UNITED STATES PATENT AND TRADEMARK OFFICE

APPLICATION NO.	FILING DATE	FIRST NAMED INVENTOR	ATTORNEY DOCKET NO.	CONFIRMATION NO.
09-929,713	08/13/2001	Ed San Mateo	2001 P 11173 US	8925

Office Action Summary

DETAILED ACTION

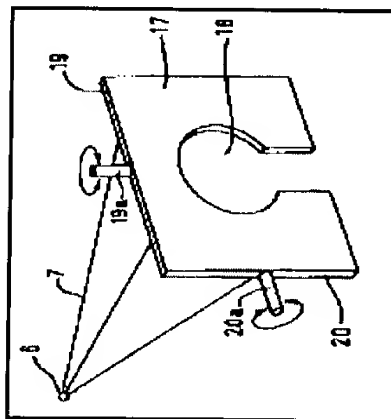
7. Claims 1-20 are rejected under 35 U.S.C. 103(a) as being unpatentable over Applicants admitted prior art in view of Maas (U.S. Patent 5,365,566).

8. As per claim 1, Applicants admitted prior art (herein after referred to as AAPA) discloses an apparatus comprising a tray portion and a coded connector coupled to the tray portion (Fig. 2; p. 2, lines 1-6). AAPA does not explicitly disclose an apparatus comprising a plurality of coded connectors coupled to the tray portion.

9. AAPA teaches an apparatus configured with a coded connector, enabling it to have a predetermined configuration within a receiving slot (p. 2, lines 1-3).

Figure 7 - U.S. Patent 5, 365, 566 to Maas

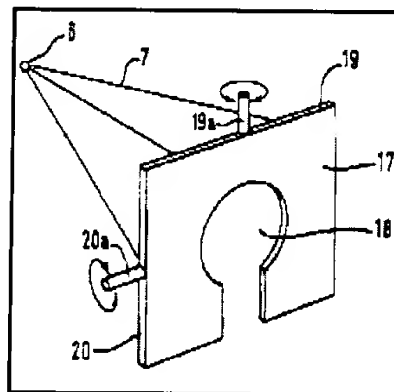
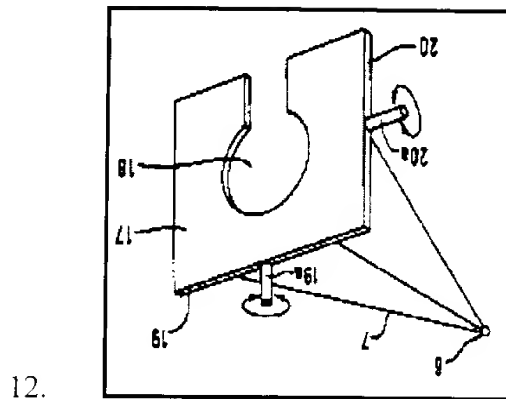
13. Maas discloses an apparatus comprising means arranged on a diaphragm for orientation and beam shaping of radiation (Fig. 7, above, column 1, lines 61-68, column 2, lines 1-2).

14. It would have been obvious to modify the AAPA such that it incorporated a plurality of coded connectors. One would have been motivated to make such a modification so that the device could be oriented in a plurality of positions, based on the arrangement of the coded connectors as taught by AAPA (Fig. 2; p. 2, lines 1-19) and further supported by the teachings of Maas (Fig. 7, above, column 1, lines 61-68, column 2, lines 1-2). Additionally, it would have been obvious to a practitioner in the art to incorporate a plurality of coded connectors, since it has been held that mere duplication of essential working parts of a device involves only routine skill in the art. *St. Regis Paper Co. v. Bemis Co.*, 193 USPQ 8.
